SUPPLEMENTAL PACKET

Re: MNDNR Comments to Afton Planning Commission for Variance Application for 3988 River Road South, Afton

Technical Memorandum

To: Joseph Bush, JP Bush Homes
From: Max Moreland, P.E.
Bryant Ficek, P.E., P.T.O.E.
Date: February 26, 2018
Re: Afton Creek Preserve Housing Updated Traffic Assessment

Figure 1 – Forecast Trip Distribution

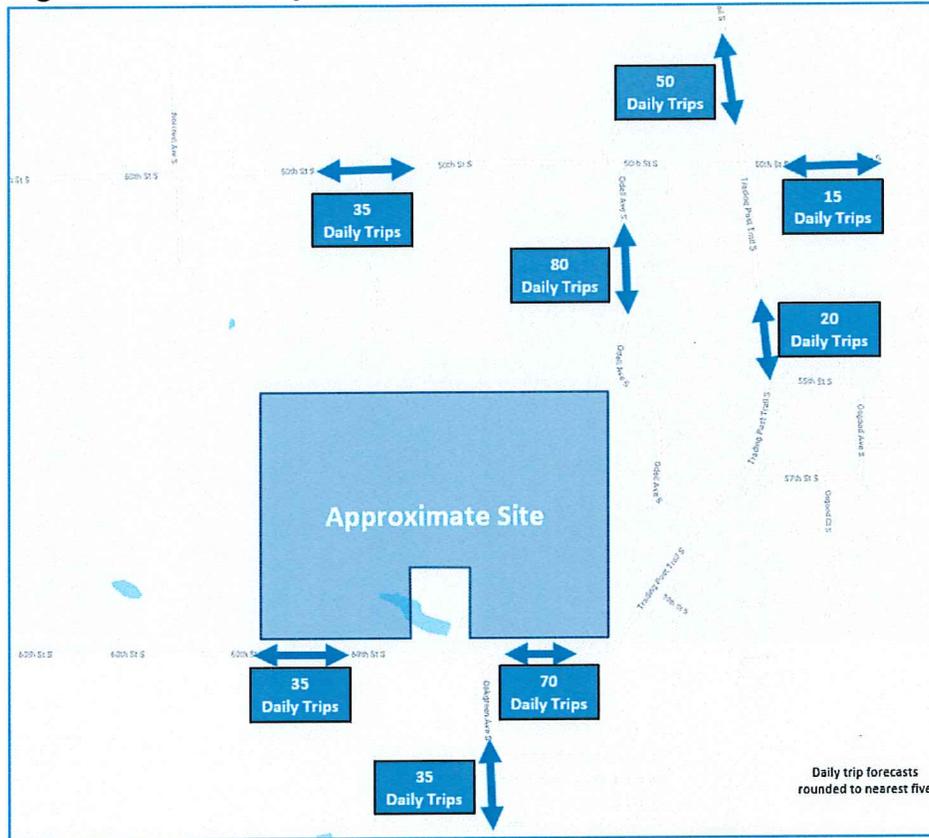
As shown, the highest daily volume on any one road is expected to be about 80 vehicles. With the p.m. peak hour typically being about ten percent of the daily volume, this translates into about eight vehicles in the busiest peak hour, or about one car every 7.5 minutes.

Figure 1 – Intersection Assessment Locations

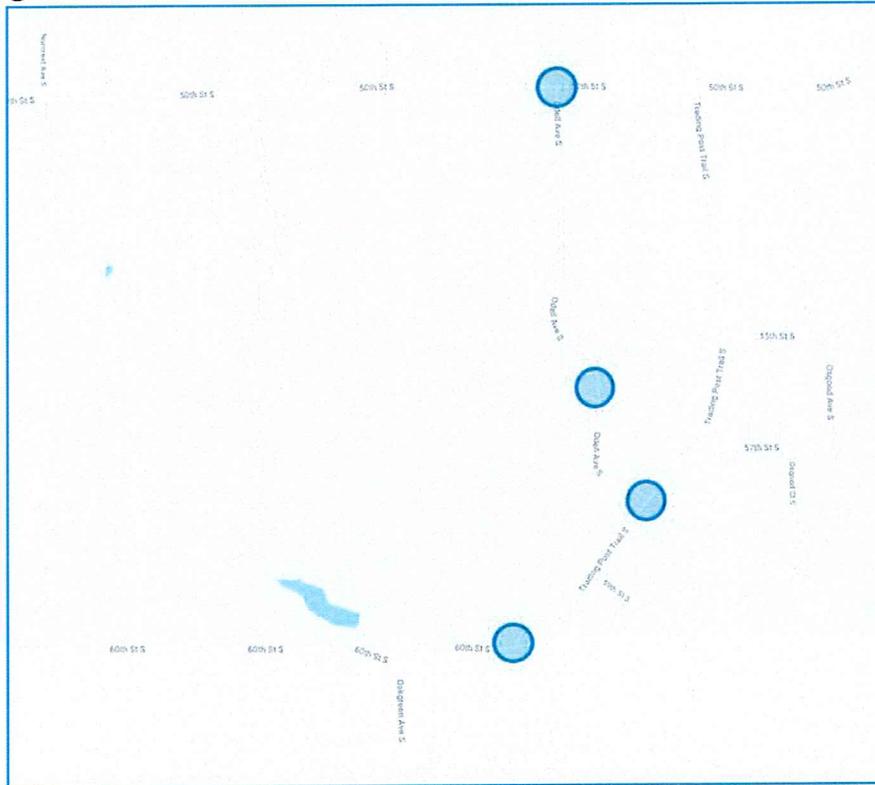
Sight distances were evaluated at four locations; the access points on 60th Street and Odell Avenue per the attached site plan as well as the Odell Avenue intersections at 50th Street and Trading Post Trail. These locations will have the greatest concentration of vehicles to/from the proposed development. Figure 2 shows those locations.

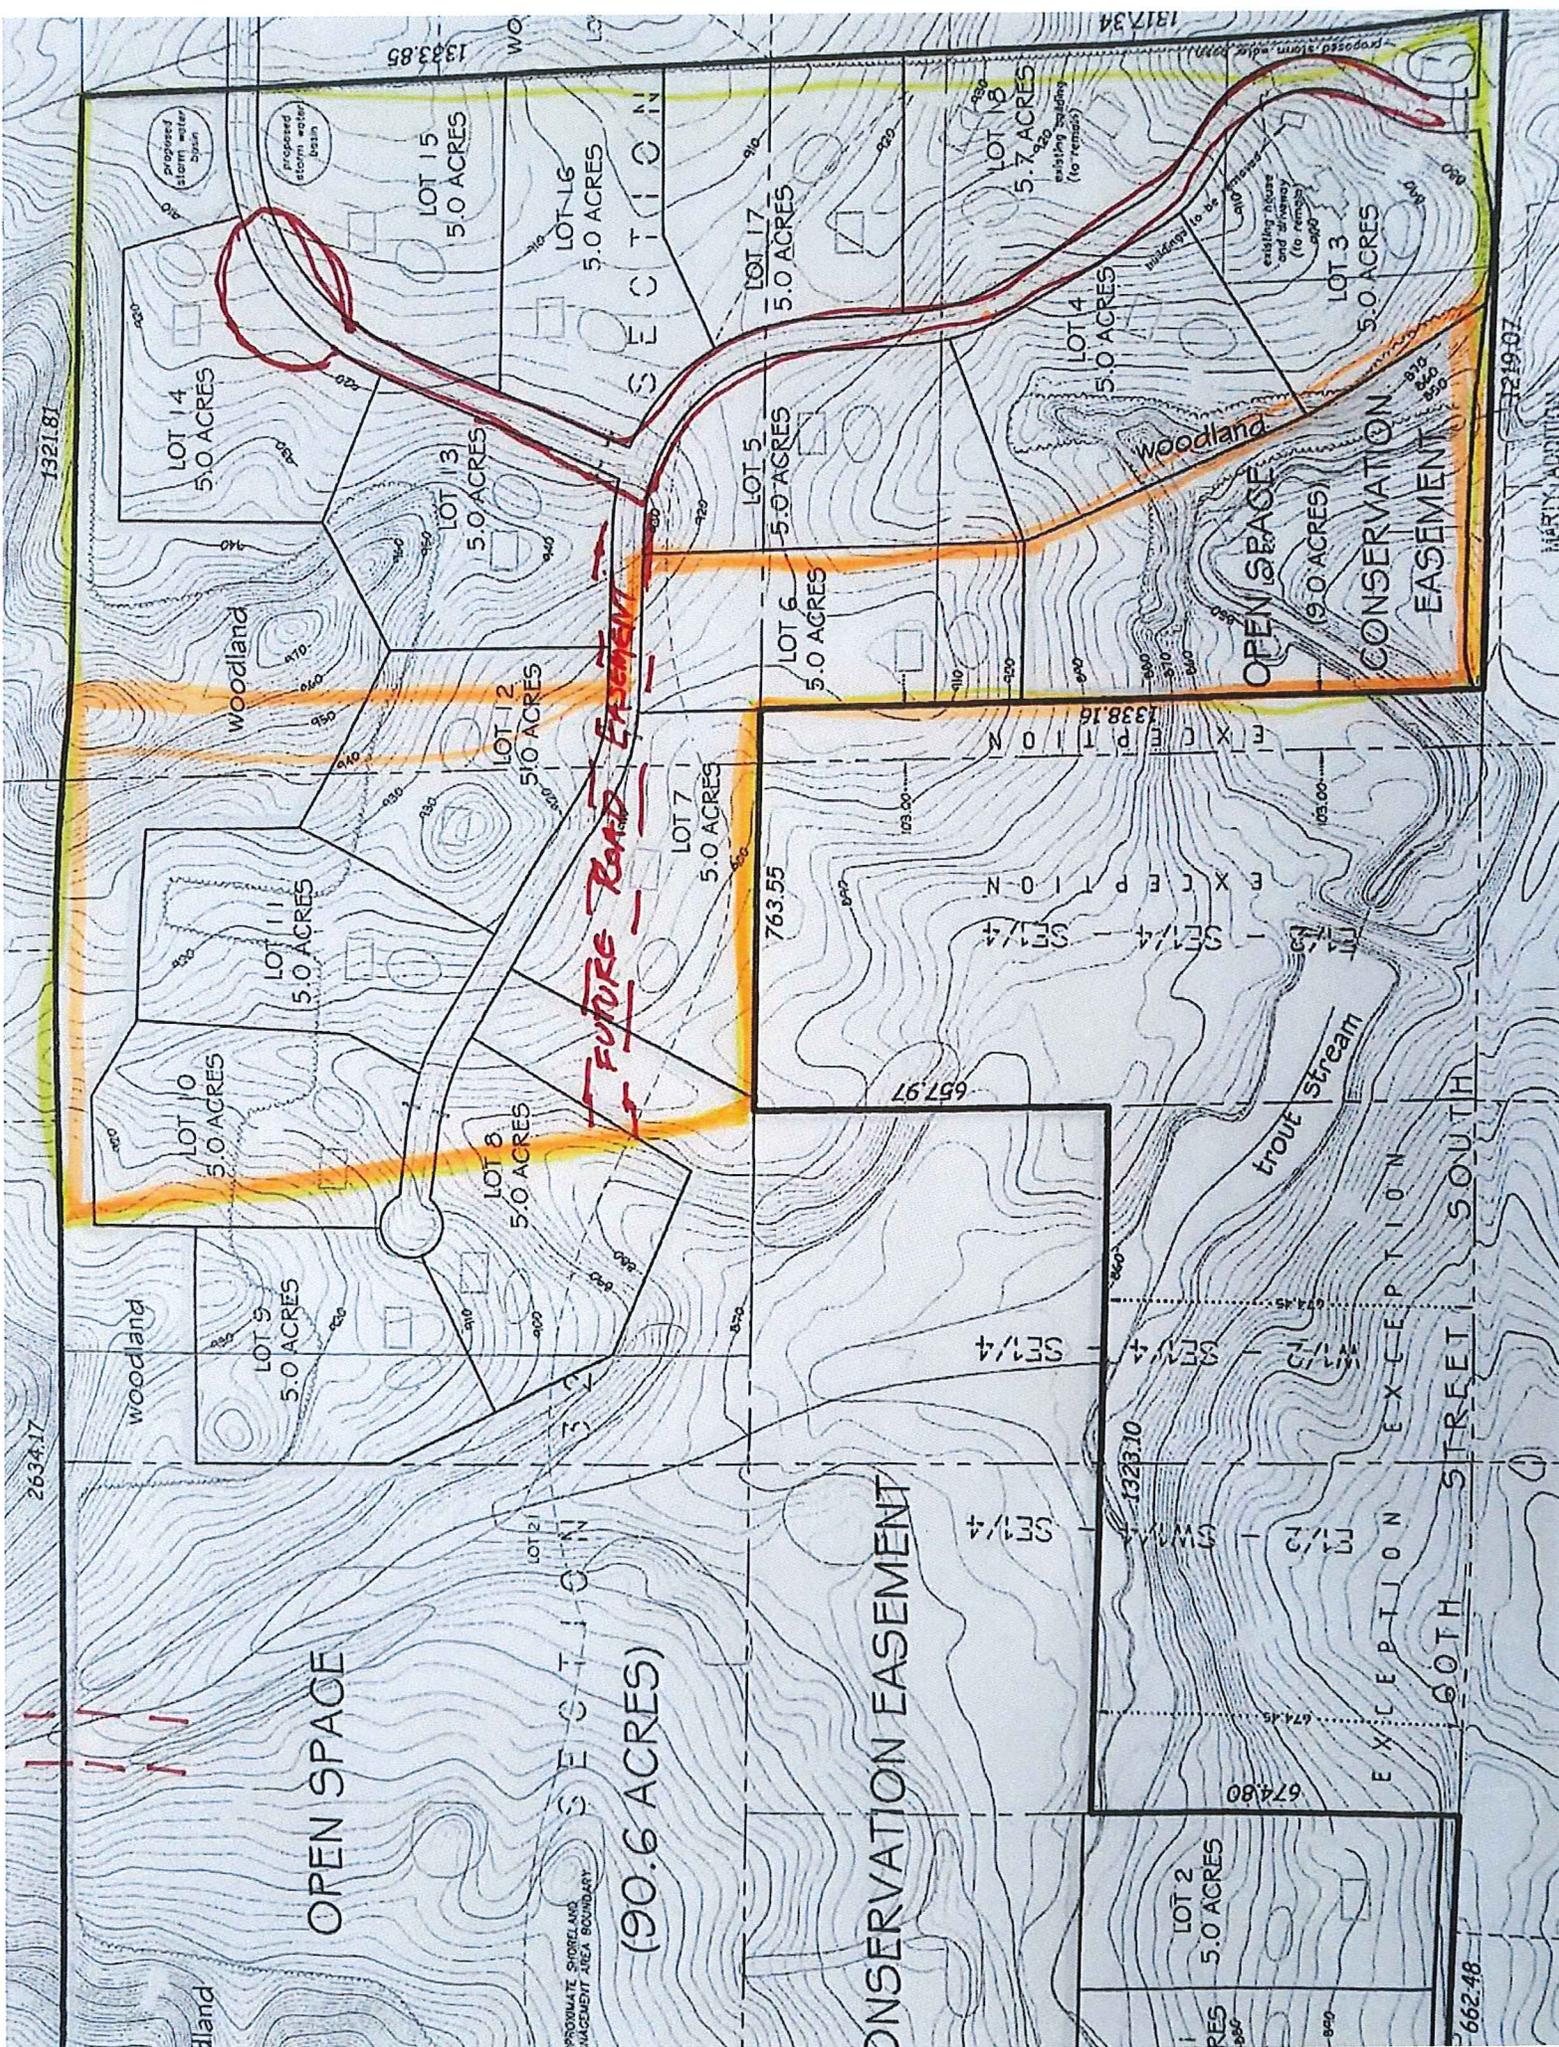
1. That plan that Mary McConnell has attached **is not my drawing.**
2. The plan Mary attached has significant discrepancies and misrepresentations to anything I have ever drawn.
3. No copy of my designs were distributed.
4. I stated that no written discussions or replies with DNR, Minnesota Land Trust, South Washington Watershed or Washington Conservation District had occurred yet.
5. As of Tuesday Feb 27th Minnesota Land Trust replied to my sketch. (see attached)

Thanks for passing along the revised site plan for our review. After a review, here are my thoughts:

- The revised plan does far less for protection of Trout Brook than any of the previous plans, and is inferior in that regard. The original design created a substantial buffer of habitat along Trout Brook. Although this design retains that buffer along the lower portion of the design, the upstream section is no longer addressed through this site plan.

- The shape of the proposed conservation easement is very irregular with significantly more edge than would be optimal from ecological and easement enforcement standpoints. As you recall, one of the main elements we addressed in the previous designs was the creation of a large block of habitat (to the extent possible) that would provide habitat for wildlife. That gets sacrificed to a significant degree through this proposed site plan.

- The site plan also places 4 lots in positions that back up to the proposed easement area. We have found that these situations often create long-term enforcement headaches through encroachment from adjacent landowners. Although there are ways to ameliorate this threat to some degree (fencing, etc.), it is unclear whether those measures are proposed here. The previous site plan also had four lots, but the conservation benefit was significantly greater.

- Finally, the potential for a road to cut across the heart of the easement area is problematic. To accommodate the potential for this road, this thoroughfare would need to be incorporated into the design of the easement area. Our preference would be to excluded it altogether from the easement area. This would effectively split the easement into two parts, which would again be a detriment to any habitat values for wildlife and add enforcement risk and associated costs going forward.

Overall, this is a significant step backward in terms of conservation value when compared with previous plans. Quite frankly, this proposed site plan would not meet the Land Trust's mission and we would not be interested in holding an easement as designed.
